SERVICE BULLETIN NO. 1

EQUIPMENT SERIES: 75S-3B/3C

EQUIPMENT TYPE: 75S-3B/3C RECEIVER

SUBJECT: IMPROVED PERFORMANCE

Figure 1

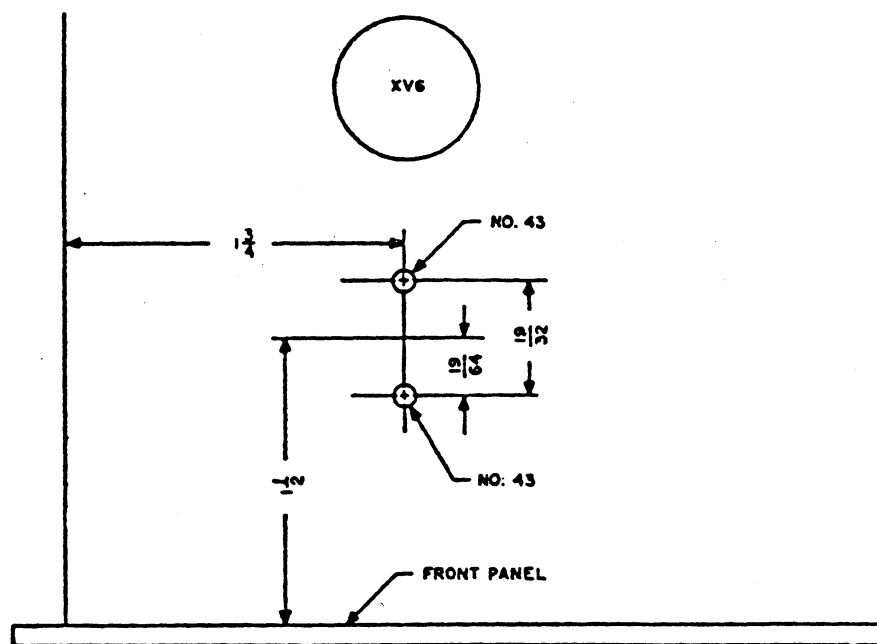
5. Referring to figure 1 remove and discard the following components connected between the points given.

18. Remove the excess screw length from the spade bolt with a sharp hacksaw.
19. Position the receiver upside down with the front panel towards you.
20. Locate and center punch a hole 3/8-inch to the right of the center of J2 (figure 1).

23. Refer to figure 2 and center punch the two hole locations.
24. Drill two 0.089-inch diameter holes using a number 43 drill bit.
25. From the top of the chassis (figure 1) locate and centerpunch a hole 3/16-inch to the left (when facing the front panel) of the left mechanical filter hold-down bar. Hole location will be to the rear of the PTO.

26. Drill a 0.147-inch diameter hole using a number 26 drill.
27. Locate and centerpunch two holes between XFL4 and XFL1 and between XFL2 and XFL3 for grd-20 and grd-21 as shown in figure 1. Use a number 4 ground lug (304-0317-000) to locate the hole. The connection point of the lugs should be placed close to the bus ground wire connecting the four filter sockets.

Figure 3

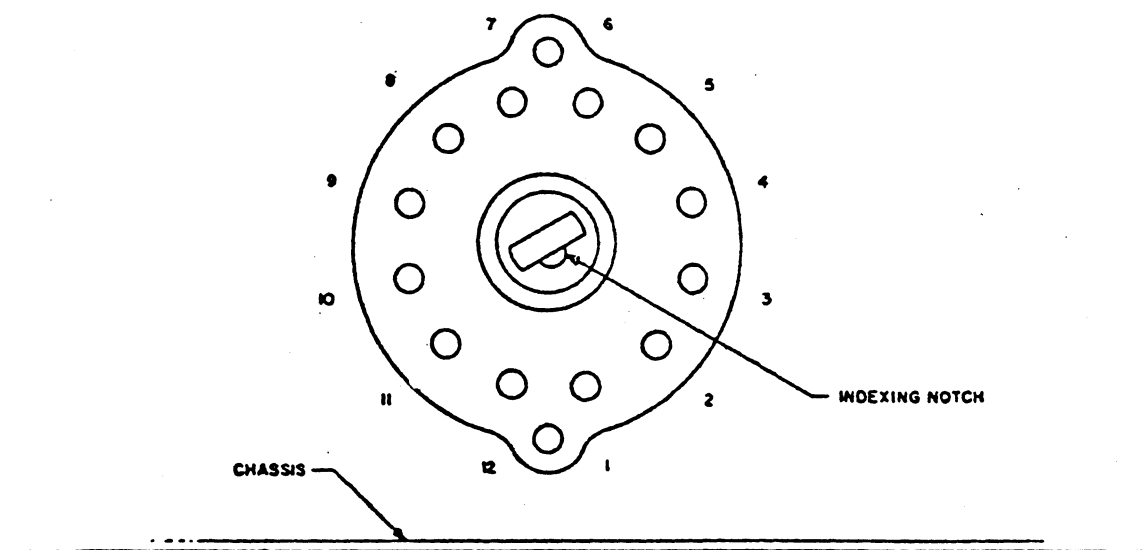
32. Mount IF transformer T9 (278-2080-010) in the location and with terminal positioned as shown in figure 3. Use two 2-56 X 1/4 screws (343-0299-000), number 2 lock washers (310-0074-000) and 2-56 nuts (313-0050-000).

34. Mount IF transformer T10 (278-0281-000) as shown in figure 3 in the former location of L9. Position terminals as shown.
35. Slide metal shaft (554-2559-002) halfway into the shaft coupling and tighten setscrew onto shaft.

Figure 5

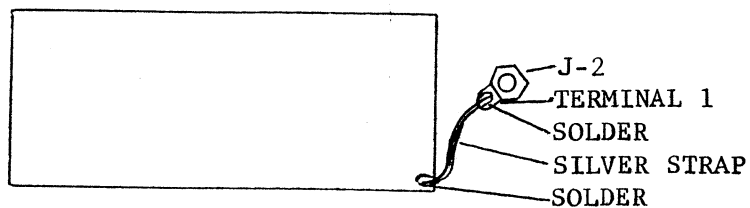
82. Install the wiring to the new jack J6 by the following steps and referring to figure 5.
 - a. Disconnect the single wire from lug 1 of the old jack and connect it to lug 2 of the new jack.

- b. Disconnect the two wires from lug 2 of the old jack and connect the black wire to lug 2 of the new jack and the white-brown-blue wire to lug 1 of the new jack J6.

- c. Disconnect the orange lead from lug 3 of the old jack and connect it to lug 3 of the new jack.
 - d. Install a new 1K resistor R92 (745-3352-000) to pin 4 from pin 3 of the new jack.

- e. Install a new 120-ohm resistor R66 (745-1314-000) to pin 4 from pin 5 of the new jack.
 - f. Solder all the new jack J6 connections.

Figure 6

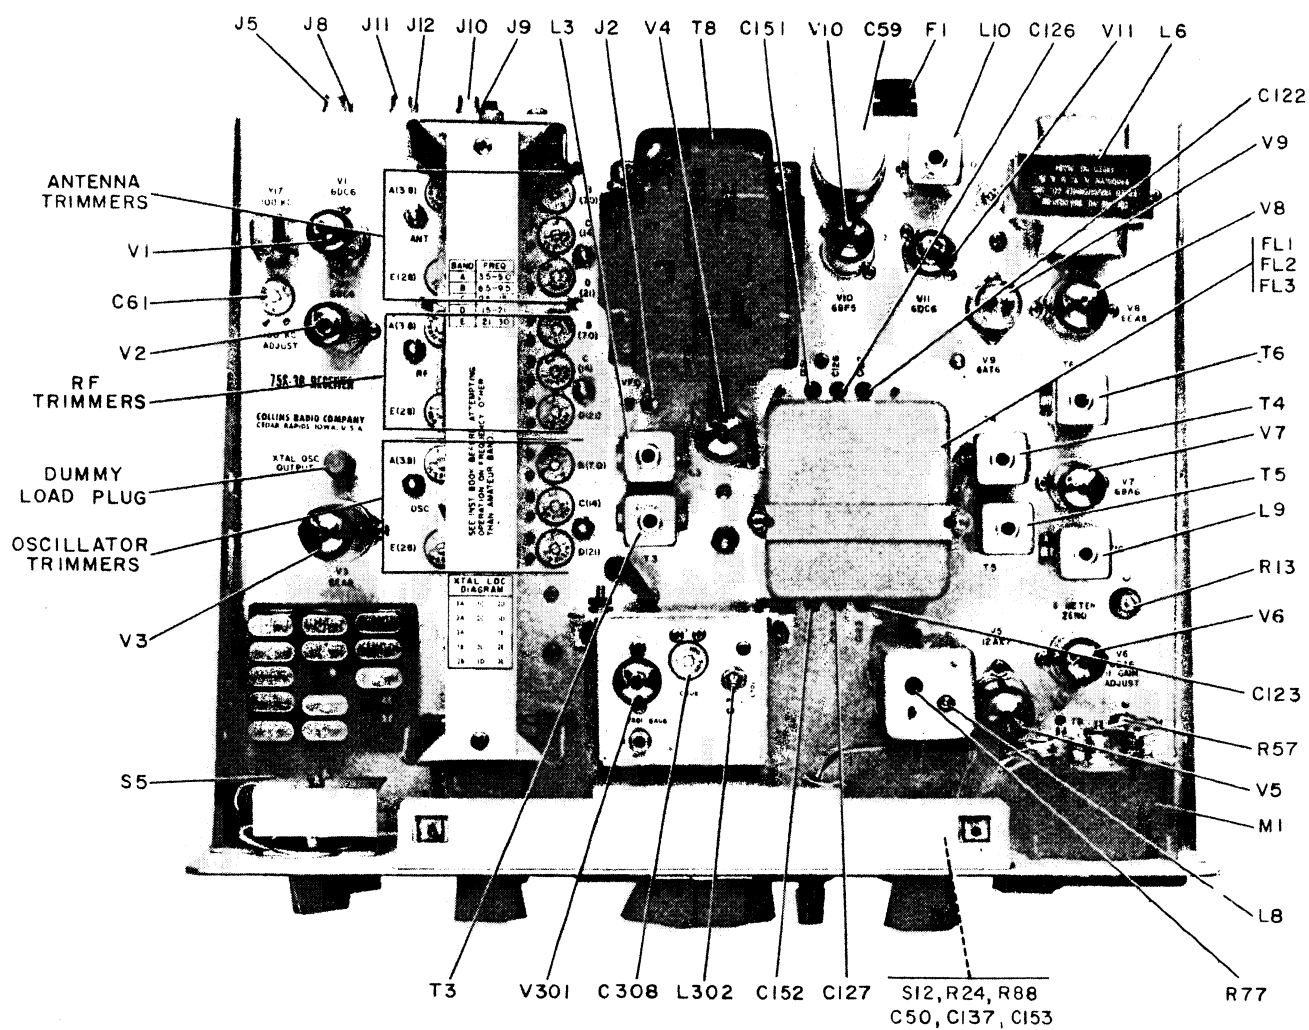
87. Referring to figure 6, install a 3-inch length of silver strap (099-3225-000) from terminal 1 (ground terminal) of J-2 (see figure 1) to the forward edge of the new cover installed in step 85. Clean and tin surface, apply strap to connection points and solder securely.
